Download: [eBug2014 chassis gitlab repository](#)

Change Log

Part numbers/colours: Part 1: BLUE, Part 2: YELLOW, Part 3: GREEN, Part 4 :RED

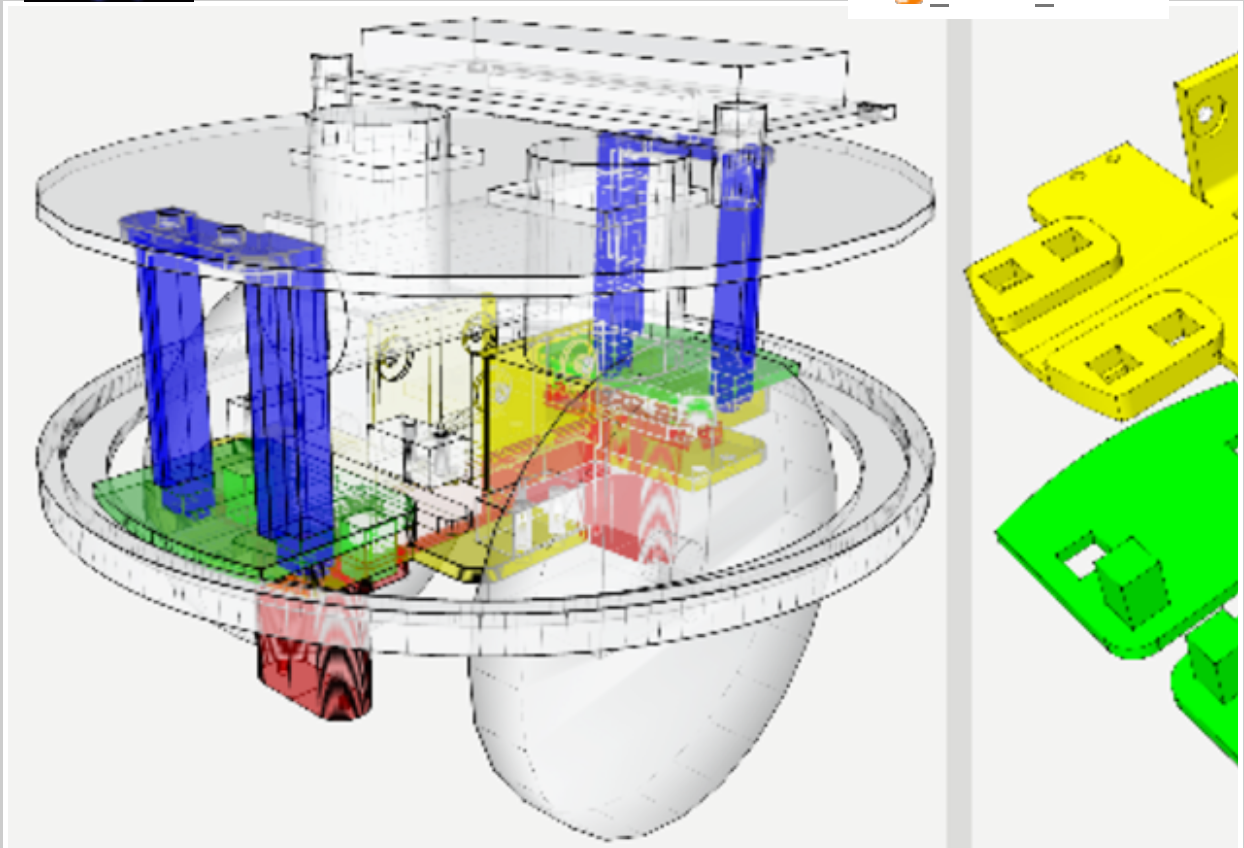
- 28/3/2016 (Matthew Boys)
 - Part 1: Added 15mm*1.5mm cut-out. Added 2.5*2.5mm blocks to strengthen pylons.
 - Part 2: Motor mounting holes: changed distance between hole from 18 to 17.5mm, Lowered holes to 5.8mm from top, Added cavity of 1mm depth and 3.2mm radius behind each hole.

- Part 2: Change pylons platform thickness to 0.5mm thicker. Lengthened pylons of parts 1 and 3 by 0.5mm too.
 - Part 2: Central bumper switch holes moved 2mm towards centre.

- Part 4: Wheel mounting holes spread to be 13.5mm apart.
 - Bumper: Pushers thickened to 3mm thick
- 4/8/2015 (Matthew Boys)
 - Part 1: Changed to print on side so printing layer weakness doesn't effect pins which kept snapping off

- Part 1,2,3,4: Changed all pins from cylinders to 50x50mm square prisms to match new Part 1
 - Part 1,2,4: Added some chamfer on the corners that experience most stress for stability and to reduce flex/wobble

- 13/7/2015 (Matthew Boys)
 - Bumper: arms breadth reduced from 45mm to 40mm to match physical version

- Bumper: Inner thickness reduced from 2mm to 1.7mm
- Sensor: New part to match physical piece. Dimensions from <http://www.switches-manufacturer.com/DM3-02P.htm>

- Part 2: Centre central bump sensor screw holes so screws will not collide with part 4
- Part 2: Enlarge all bump sensor screw holes from 1.8mm to 2mm diameter

- Part 2: Remove notch from wall as no-longer needed
- 16/6/2015 (Matthew Boys)
 - Part 2: Move screw holes for central bump sensors towards the centre axis by 3mm to

- Part 2 & 3: Shaved 1mm from the wall the retracting bumper hits to allow more bumper movement. From both top and bottom pieces
 - Part 1: Reduced the pentagonal pin diameter from 4mm to 3.8mm to allow better fit into hole (was too tight)

- Part 2: Adjusted motor wall cutout to be 6mm x 3mm with triangle above for printing stability and avoid collision with sensors.
 - Part 3: Extended the top bumper guide out by 7mm to reduce wobble of bumper.

- 7/6/2015 (Matthew Boys)
 - Part 2: Enlarged screw holes for all bump sensors from 1.5mm to 1.8mm diameter
 - Part 3: Cut edges of plate and bumper guide down to a maximum radius of 50mm to avoid hitting the bumper

- Part 2: Moved screw holes of central two bump sensors back 2mm to allow more bumper movement
 - Part 2: Added cut-out in motor wall for wires from bump sensors

- Part 4: Added wall between two wheel supports for more stability
 - Part 1 & 2: Moved support columns back 2mm to avoid bumper hitting edge
 - Part 1 & 2: Changed pins on support column from circles to pentagons (so they won't go on backwards by mistake)

- 25/5/2015 (Matthew Boys)
 - Part 1: Wider top screw holes to make screws fit better. Hole diameter changed from 2.5mm to 2.8mm
 - Part 4: Slightly deeper screw holes for attaching feet rollers

- Part 2: Slightly wider motor support walls to avoid breakages near the screw holes
 - Part 2: Slightly thicker motor support walls to reduce change of breakage

- 18/5/2015 (Matthew Boys)
 - All: Rebuild from scratch at 100x scale to reduce errors in files
 - All: Add rounded corners and screw holes
 - Part 1: Thicker support posts to reduce chance of breakages

- 23/3/2015 (Matthew Boys)
 - Part 3: Import existing file to [SketchUp](#)
 - All: Recreate eBug hardware in [SketchUp](#)
 - All: Develop initial design in four types of pieces
